STAFF REPORT

SUBJECT: **ARANUI ROAD TRUST - REPORT EP07/12/07** - Report prepared for 19 and 20 December hearing

TO: Environment & Planning Subcommittee
FROM: Dugald Ley, Development Engineer
DATE: 11 December 2007
REFERENCE: RM070637
SUBJECT: **SUBDIVISION – 96 RESIDENTIAL LOTS, 5 RESERVE AREAS,
ROAD TO VEST AND ONE INTERIM LOT FOR WATER
COLLECTION AND STORAGE**

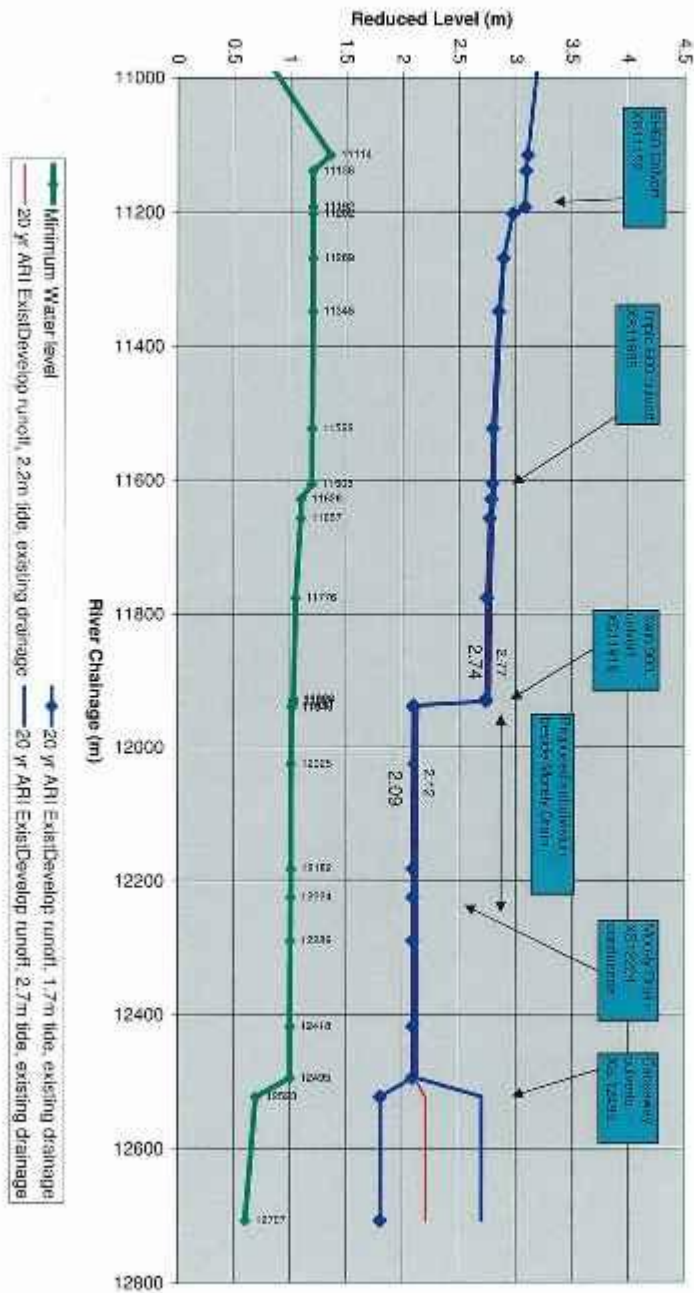
For a 20% AEP rainfall on the “subdivision catchment” discharging to the upper estuary, stormwater does not reach a surcharge level that causes ponding in the subdivision roading network.

This just begins to occur to a minor degree (22mm depth, 34 litres/sec discharge) under a 5% AEP rainfall event. Under a 1% AEP rainfall in the “subdivision catchment”, ponding in the subdivision road network occurs to approximately 200mm depth.

While estuary water levels remain at or below RL 2.1m, current design performance criteria for stormwater reticulation performance (current 20% AEP rainfall and future 10% AEP rainfall), where no stormwater ponding occurs in the street, is met. Greater rainfall intensity in the subdivision catchment, or significant rainfall in the Seaton Valley catchment, that increases estuary water levels above RL 2.1m, will cause flooding in the subdivision roading network. This is modelled by Mr McCartin, with 1% and 5% AEP rainfall in the subdivision catchment discharging to the estuary having a water level of RL 2.5m amsl. Floodwater depths of 178mm and 14 mm respectively will occur in the streets under these scenarios. In all cases where inundation of the street network occurs, flood hazards can be managed through the requirement for secondary overland flow path mechanisms to the estuary to be provided and preserved.
